I have reviewed the drainage report for La Ultima de la Ciudad with the revisions and amendments submitted by letter dated September 7, 1977. I am in agreement with the concepts outlined. The drainage report is therefore approved.

Re: La Ultima De La Ciudad, Unit 2

SUBJECT: SPROUL SECURITY SUBDIVISION, TRACT 1,
LA ULTIMA DE LA CIUDAD, UNITS 1 AND 2,
DRAINAGE REPORT

RAINAGE REPORT
FOR
TWO PARCELS OF LAND
WITHIN THE
SPROUL SECURITY SUBDIVISION
TRACT 1
LA ULTIMA DE LA CIUDAD
UNITS 1 AND 2
ZONE ATLAS SHEET H-23

DESIGN OF DESILTING POND

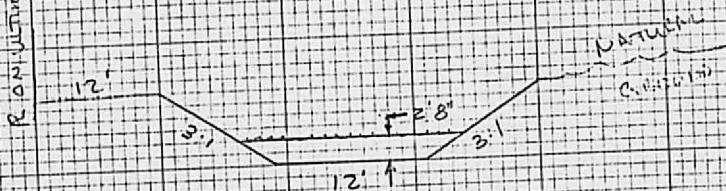
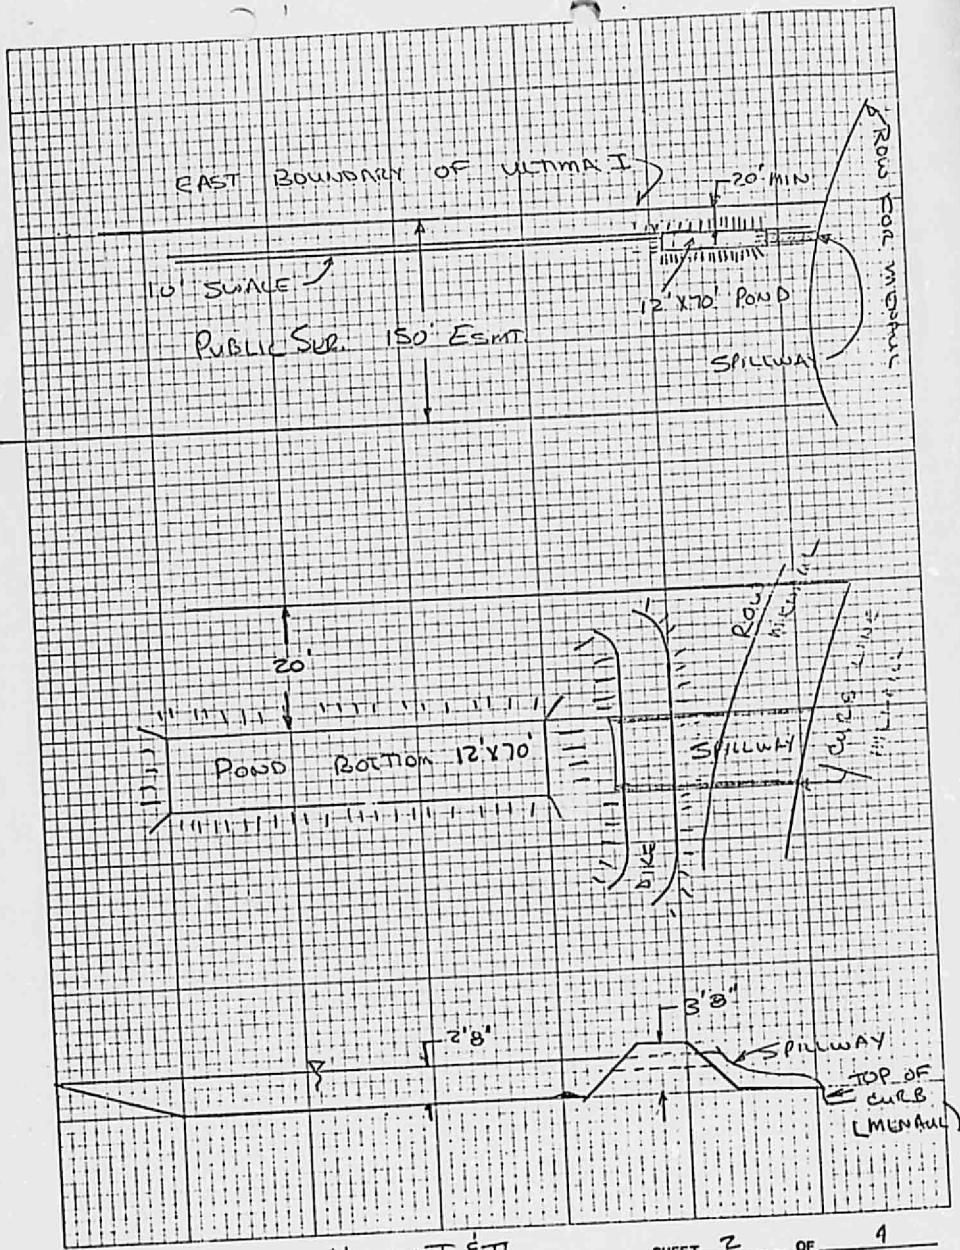
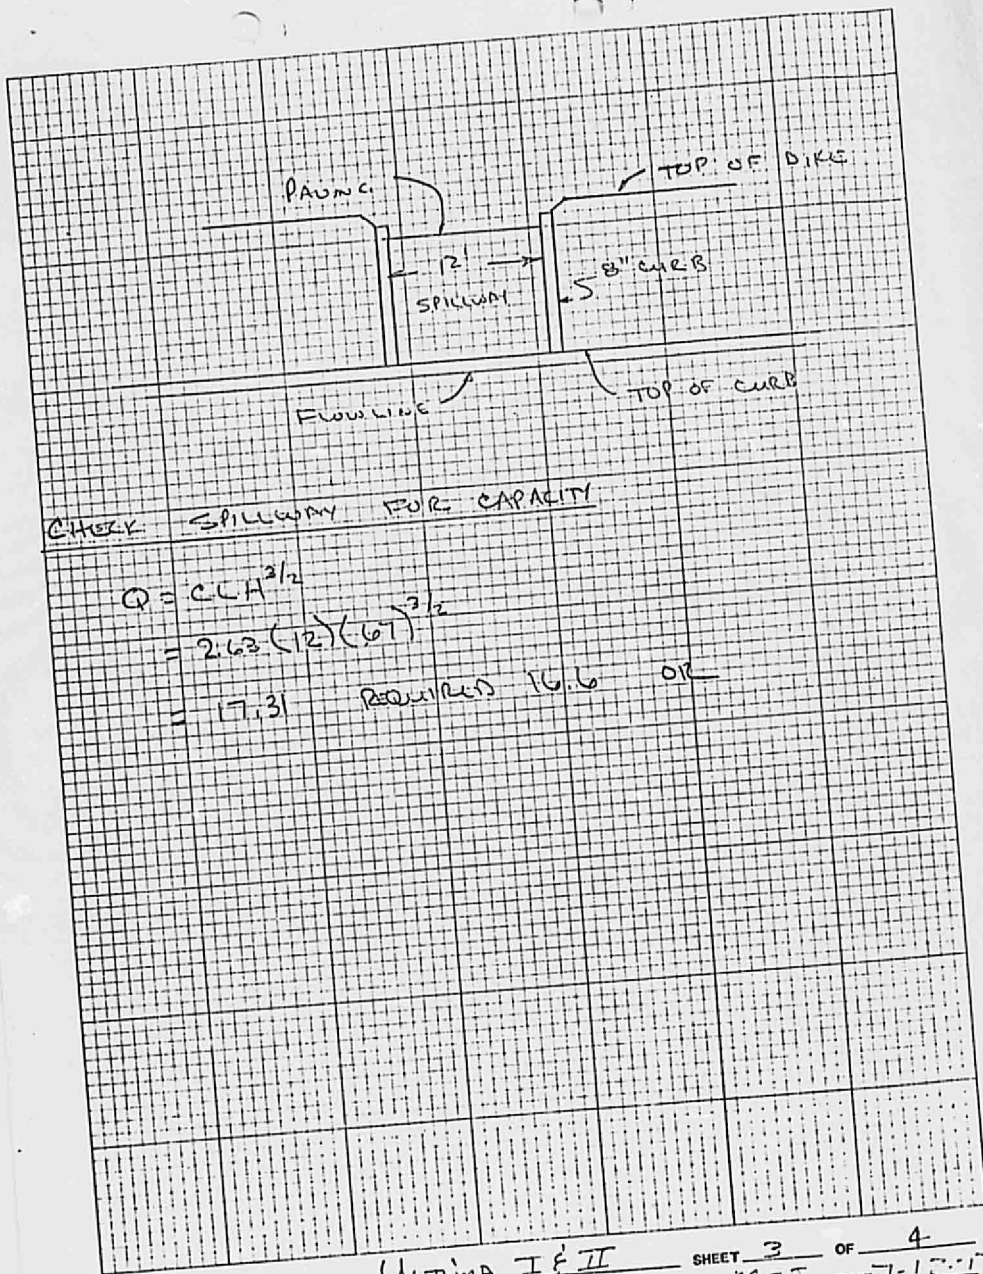
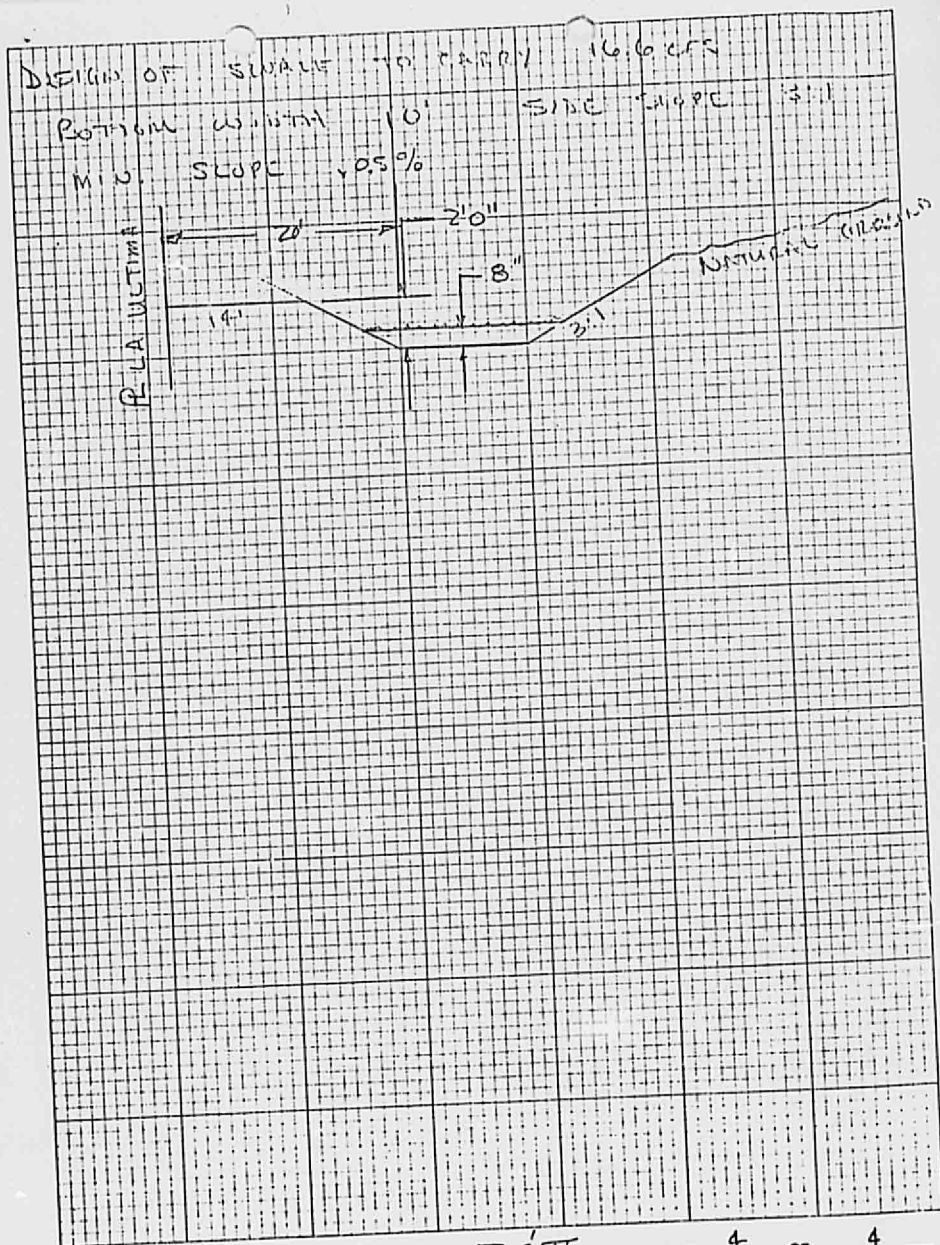
1. In the report, it is recommended that a swale be constructed along the east side of the north parcel to intercept and carry upland runoff north to Menaul Boulevard. In conjunction with this, and per your request of June 27, 1977, we would like to add the following to the recommendations for the north parcel:

"A desilting basin should be constructed at the point where the swale reaches Menaul Boulevard, extending 70' back along the swale. The basin should be approximately 12' wide and 2'-8" deep. A spillway 12' wide and 2'-8" high should be set in the exit end of the basin."

Enclosed for your reference is a location map and sketches of the proposed improvements.
